Agenda Item # 11

SUB-003444-2025 & MOD-003516-2025

- Subdivision approval to create two (2) legal lots of record
- Modification of a previously approved Planned Unit Development

APPLICATION NUMBER 11 DATE November 20, 2025
 APPLICANT Radcliff-Ice Plant Subdivision
 REQUEST Subdivision, PUD Modification

PUD SITE PLAN

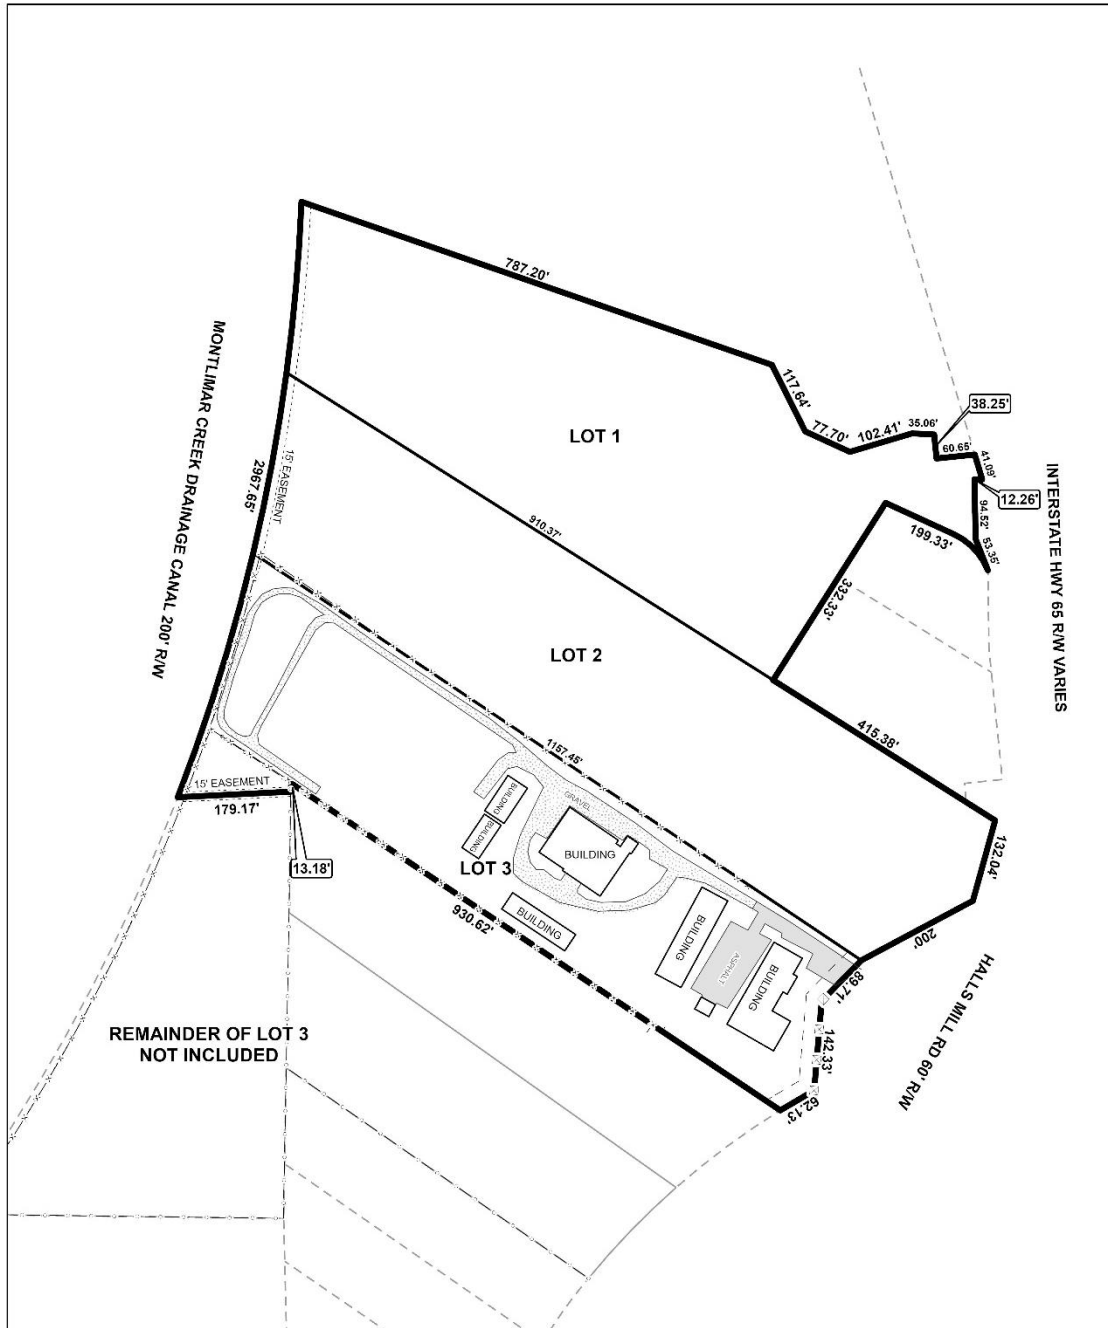
- 1. Show the boundary of the proposed site for the PUD. The drawing does not include the proposed LOT B of the subdivision.
- 2. Remove the note "THIS PORTION OF LOT 3 IS HEREBY REMOVED FROM THE PUD" shown on the drawing since there is no LOT 3 shown or listed in the proposed subdivision.

The site plan depicts the proposed modification to the property lines of Lot 3 of the Ben Radcliff Subdivision and Lot A of the Middleton Subdivision, consistent with the concurrent subdivision request. A note on the plan states that a "...portion of Lot 3 is hereby removed from the PUD." The plan also illustrates existing site improvements on the remainder of Lot 3, including several buildings utilized by the current contractor business.

The required 25-foot front yard setback is illustrated along Halls Mill Road but not along West I-65 Service Road South. If approved, the 25-foot front yard setback should be depicted along all street frontages, adjusted as necessary for any required dedication resulting from the subdivision request.

Existing site improvements are illustrated on the plan and are located entirely within proposed Lot A. While no new improvements are proposed with this request, each existing building should be labeled with its square footage. Additionally, the Final PUD Site Plan should be revised to depict all other existing site features, including off-street parking areas, loading zones, driveways, and maneuvering areas.

Parking calculations for any required or existing parking should be provided in a table on the Final PUD Site Plan. All curbing and/or wheel stops should also be clearly illustrated.

Any existing dumpsters or dumpster enclosures should be shown on the Final PUD Site Plan. If curbside waste collection is provided instead, a note indicating this should be included on the plan.

1. Revision of the Final PUD Site Plan to label the size of each lot in both square feet and acres, adjusted for any required dedication resulting from the subdivision approval, or provision of a table on the Final PUD Site Plan with the same information;

2. Revision of the Final PUD Site Plan to illustrate the 25-foot front yard setback along all street frontages;
3. Revision of the Final PUD Site Plan to label each existing building with its size in square feet;

4. Revision of the Final PUD Site Plan to depict all other existing site features;
5. Provision of a table on the Final PUD Site Plan showing required and existing parking calculations;

6. Revision of the Final PUD Site Plan to illustrate any/all curbing and/or wheel stops;
7. Revision of the Final PUD Site Plan to depict any dumpsters or dumpster enclosures, or provision of a note on the Final PUD Site Plan stating curbside waste collection is utilized;

SUBDIVISION SITE PLAN

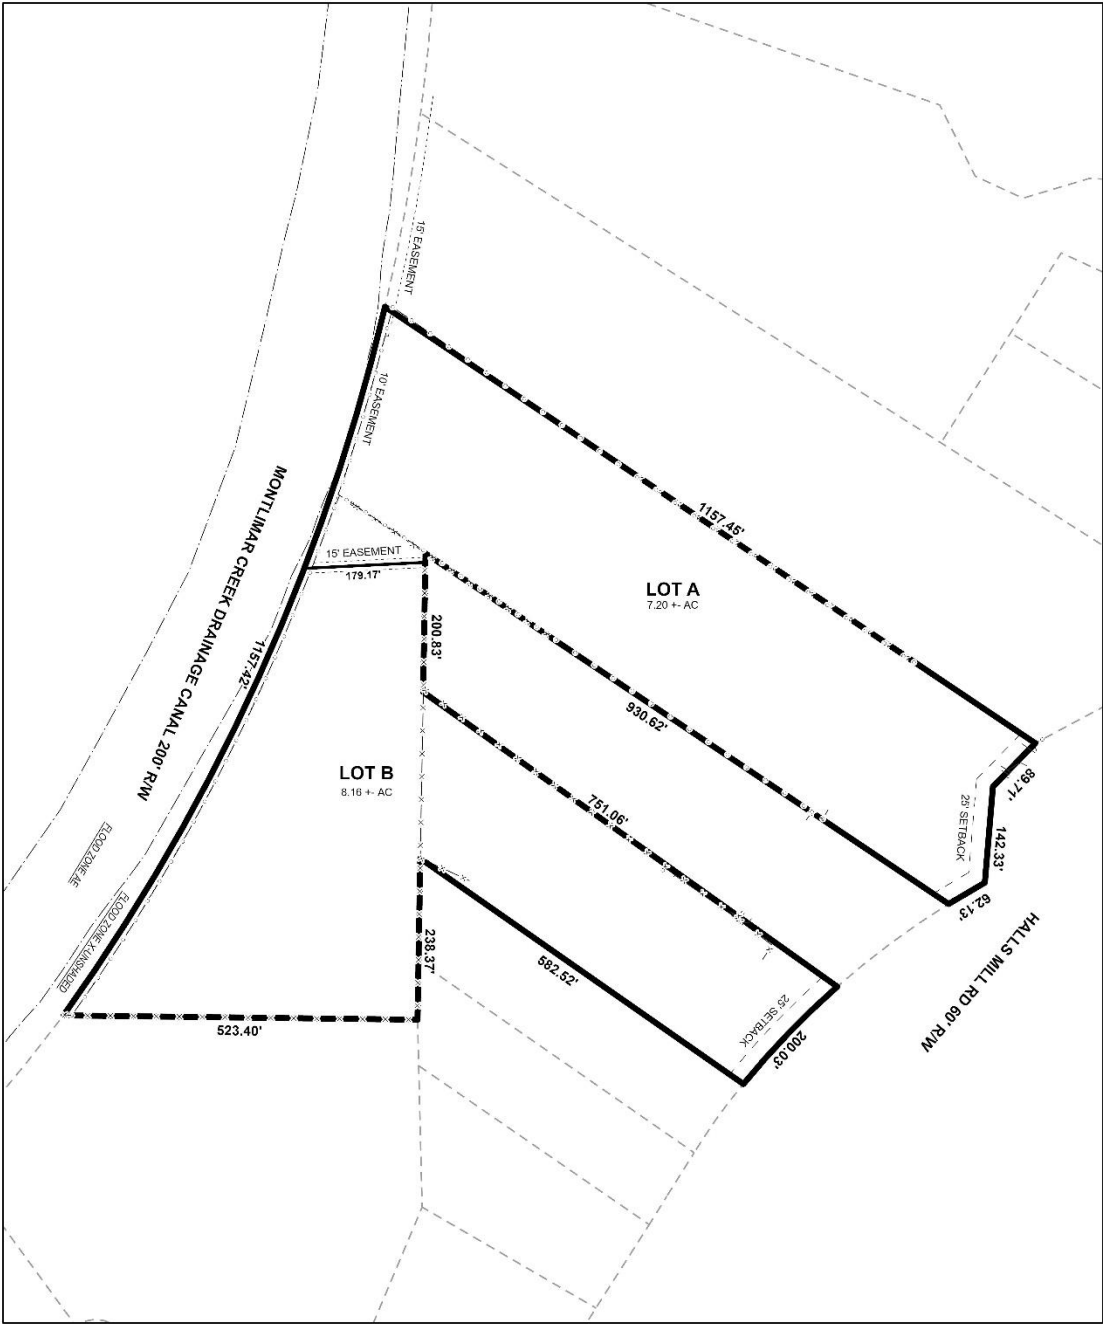
The plat currently depicts a 60-foot-wide right-of-way along Halls Mill Road and a variable right-of-way along West I-65 Service Road South. A previous 35-foot dedication from the centerline of Halls Mill Road was required for the Middleton Subdivision; therefore, the plat should be revised to depict adequate right-of-way along both proposed lots, unless the Planning Commission waives Section 6.C.9. of the Subdivision Regulations.

Although the preliminary plat shows a variable right-of-way along West I-65 Service Road South, aerial imagery and mapping data indicate that sufficient right-of-way already exists at this location. Accordingly, the Final Plat should depict the greater of either the existing right-of-way or the required 300-foot standard along West I-65 Service Road South.

Both lots abut the Montlimar Creek Drainage Canal to the west, which is shown with a 200-foot-wide right-of-way consistent with previous subdivisions of the site. This information should be retained on the Final Plat, if approved.

There is no minimum lot size requirement for properties served by public water and sanitary sewer within an I-1, Light Industry District. However, Section 5.A.2(e)(4) of the Subdivision Regulations requires each lot's area to be labeled in both square feet and acres. This information is shown on the preliminary plat and should be retained on the Final Plat, adjusted as necessary for any required dedication. Alternatively, a table with the same information may be provided on the Final Plat.

A 25-foot front yard setback line is illustrated along both street frontages, in compliance with Section 6.C.8. of the Subdivision Regulations and Article 2, Section 64-2-21.E. of the Unified Development Code (UDC) for lots in the I-1 zoning district. This information should also be retained on the Final Plat, adjusted for any required dedication.

Both lots exceed the maximum depth-to-width ratio of 3.5:1 at the front yard setback line, which is discouraged by Section 6.C.3. of the Subdivision Regulations. However, considering prior subdivision approvals for the site and similar lot configurations within the surrounding area, a waiver of Section 6.C.3. may be appropriate.

A 10-foot-wide drainage easement is shown along the rear portion of each lot, adjacent to the Montlimar Creek Drainage Canal. Therefore, a note should be required on the Final Plat stating that no structures may be constructed within any easement without the written consent of the easement holder.

1. Revision of the Final Plat to depict dedication sufficient to provide 35 feet from the centerline of Halls Mill Road, in compliance with Section 6.C.9. of the Subdivision Regulations;

2. Revision of the Final Plat to depict the minimum existing right-of-way width or a dedicated 300-foot-wide right-of-way, whichever is greater, along West I-65 Service Road South;

3. Retention of the 200-foot-wide right-of-way for the Montlimar Creek Drainage Canal as illustrated on the preliminary plat;
4. Retention of the lot size labels in square feet and acres on the Final Plat, adjusted for any required dedication, or provision of a table on the Final Plat with the same information;

5. Retention of the 25-foot front yard setback along both street frontages on the Final Plat, adjusted for any required dedication;
6. Provision of a note on the Final Plat stating that no structures shall be constructed in any easement without consent of the easement holder;
